## DEVELOPMENT APPLICATION

<b>APPLICATION NUMBER:</b>	PLN-26-019
<b>PROPOSED DEVELOPMENT:</b>	Additions and alterations to Secondary School (Educational and Occasional Care)
<b>LOCATION:</b>	62 Ashbourne Grove West Moonah
<b>APPLICANT:</b>	MC Planners
<b>ADVERTISING START DATE:</b>	24/03/2026
<b>ADVERTISING EXPIRY DATE:</b>	10/04/2026

**DEVELOPMENT APPLICATION - CARPARK EXTENSION (17 ADDITIONAL SPACES), NETBALL COURT WITH ROOF, AND ASSOCIATED WORKS - ST FRANCIS FLEXIBLE SCHOOL, 62 ASHBOURNE GROVE, WEST MOONAH**

PROJECT NO.	<b>250610CS</b>
DWG NO.	<b>C01</b>
REVISION	<b>DA1</b>
PLOT DETAILS	250610CS - GENERAL ARRANGEMENTS.DWG

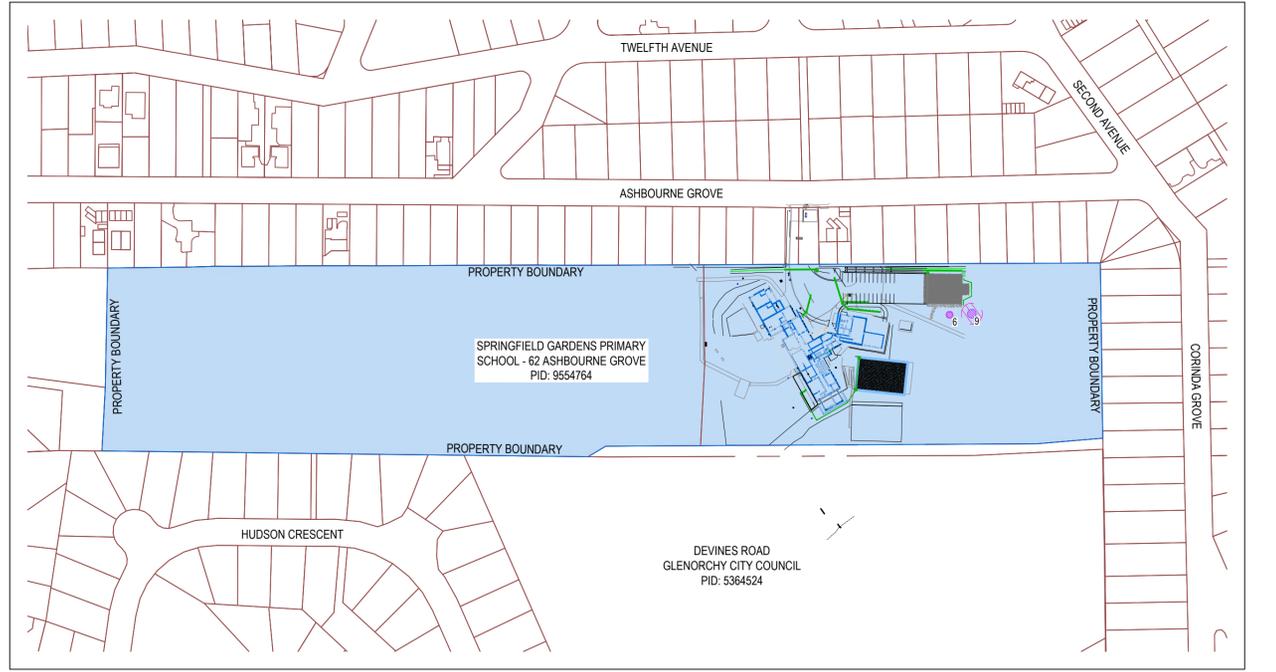
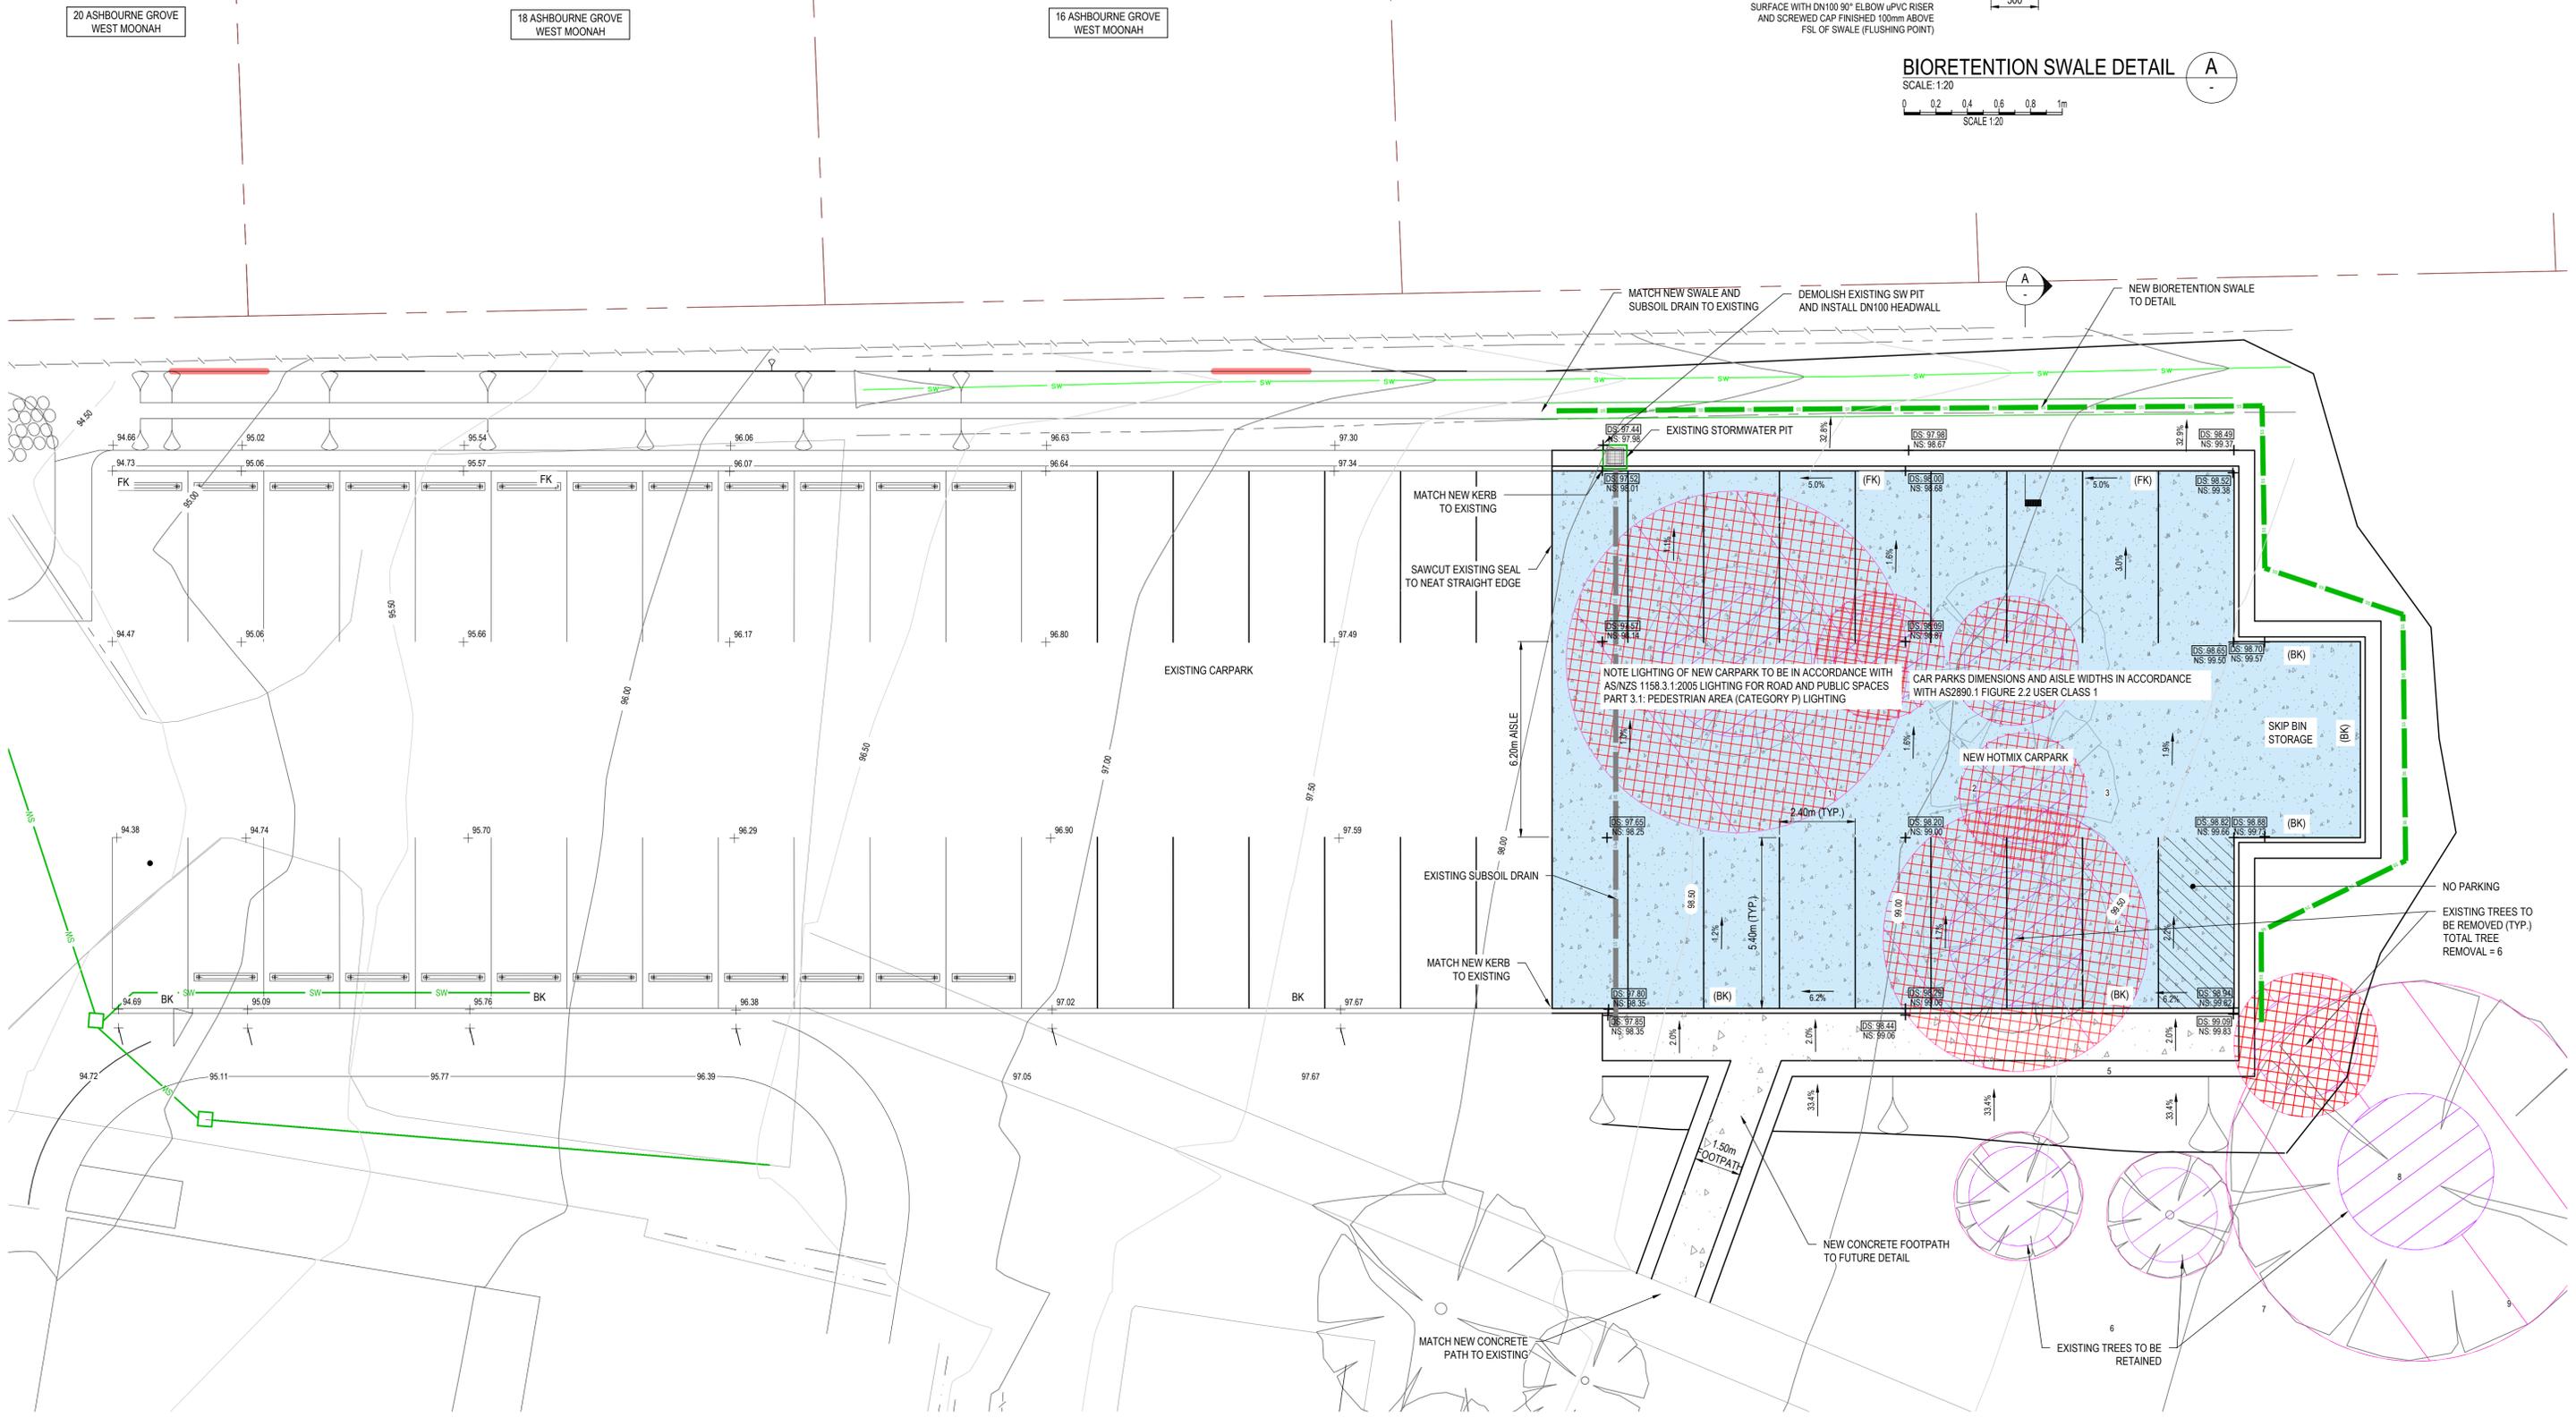
- *The documentation notes that the number of parking spaces exceeds the requirement, stating that 67 spaces are provided. However, the plans provided show 56. While this may exceed the requirement, please provide consistent documentation.*
- *Additionally, documentation states that there will be 18 new car spaces provided. Plans provided show 17 new spaces. Please update documentation accordingly to confirm which it is.*

- *The documentation states that bicycle spaces are provided on site, however, these are not shown on plans.*

Project No. 250610CS, Drawing No. C01-3 shows the proposed new stormwater pits, drains and spoon drain for the netball court and carpark connecting to the existing stormwater drainage on the site that is connected to the public stormwater system.
